UNITED STATES PATENT AND TRADEMARK OFFICE

APPLICATION NO.	FILING DATE	FIRST NAMED INVENTOR	ATTORNEY DOCKET NO.	CONFIRMATION NO.
10/614,562	07/07/2003	Paul F. Van Epps	PFV-127	5829
37282	7590	12/18/2006	EXAMINER	
HOWARD J. GREENWALD P.C. 349 W. COMMERCIAL STREET SUITE 3075 EAST ROCHESTER, NY 14445-2408			GIRARDI, VANESSA MARY	
			ART UNIT	PAPER NUMBER
			2833

Office Action Summary

DETAILED ACTION

6. Claims 1 and 10-12 are rejected under 35 U.S.C. §103(a) as being an obvious variant of Magee (Des. 340,062).

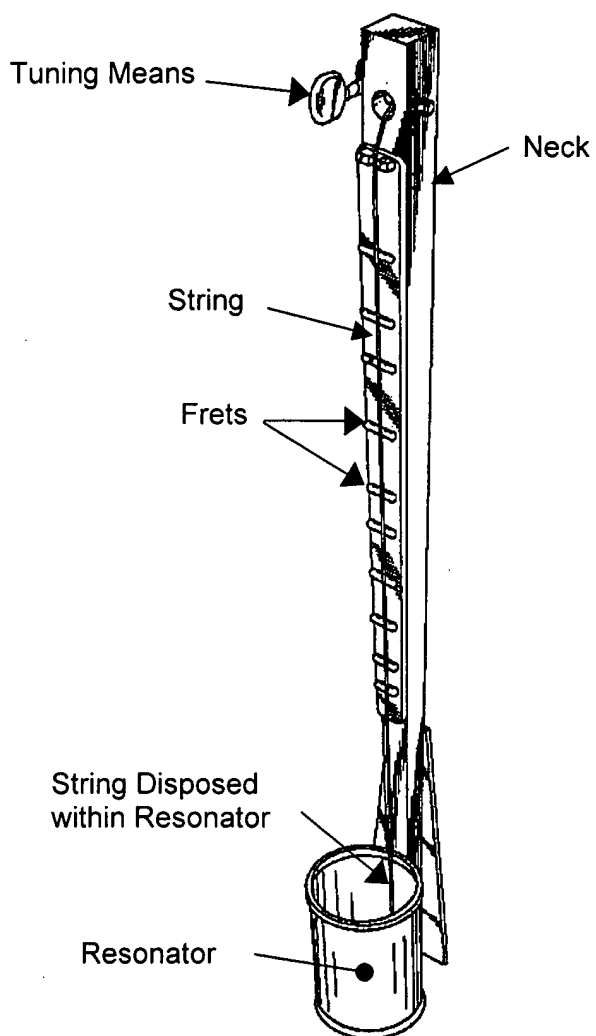
With respect to claim 1; Magee shows an instrument assembly comprised of a neck, a string disposed on the neck, and a resonator, wherein: the resonator is comprised of a cavity defined by an inner wall of the resonator, the string is disposed on the neck, a first portion of the string is disposed within the resonator, and a portion of the string extends through the resonator, and at least three chromatic frets are disposed on the neck.

However Magee does not show the neck is disposed *within* the cavity, attached to and contiguous with the *inner* wall of the resonator.

It has been held *In re Japikse*, 181 F.2d 1019, 86 USPQ 70 (CCPA 1950) the mere rearrangement of parts is not patentability distinct because shifting the position of the neck from the outer wall to the inner wall of the resonator has not been disclosed by the Applicant as a criticality which modifies the operation of the instrument.

Therefore, it would have been obvious to a person of ordinary skill in the art at the time the invention was made the invention would perform equally well with either configuration.
